8A Miscellaneous Electrical Systems

The information in this appendix of the reference ABWR DCD, including all Subsections and figures, is incorporated by reference with the following departures and supplements.

Figure 8A-1 Site Plan (Grounding)

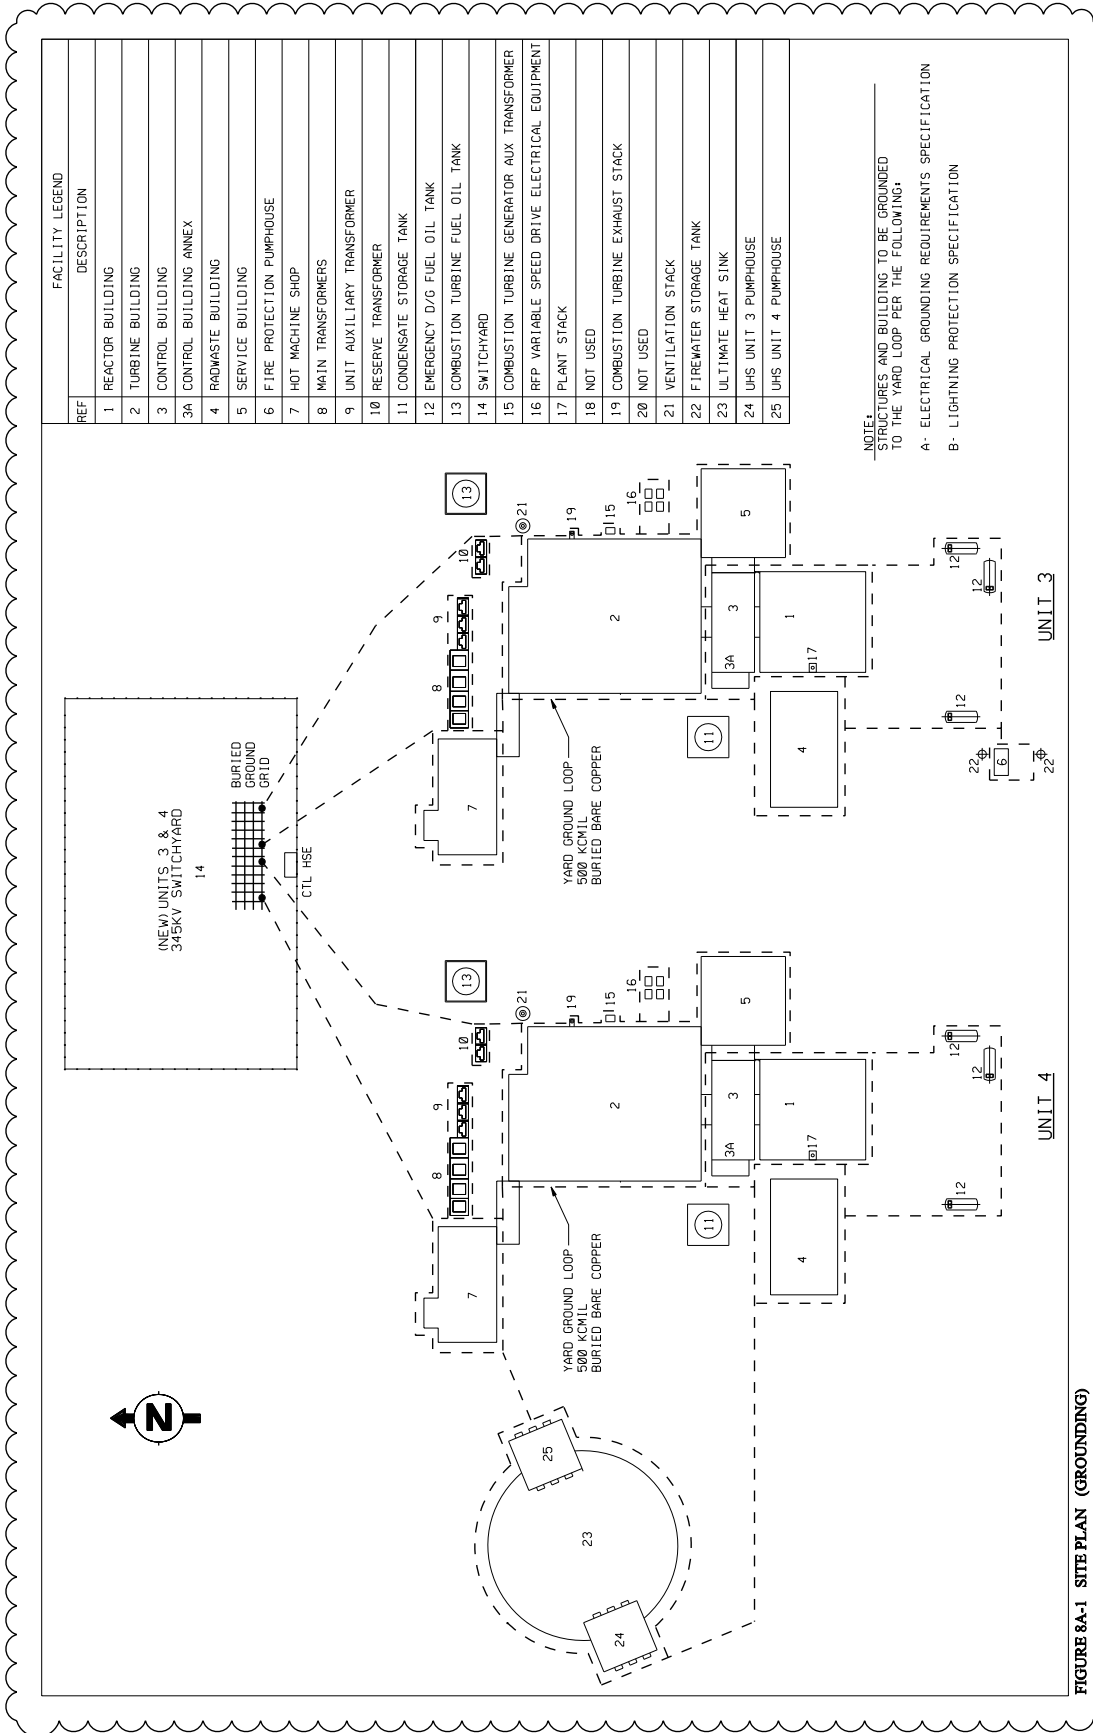
STP DEP 1.1-2 (Figure 8A-1)
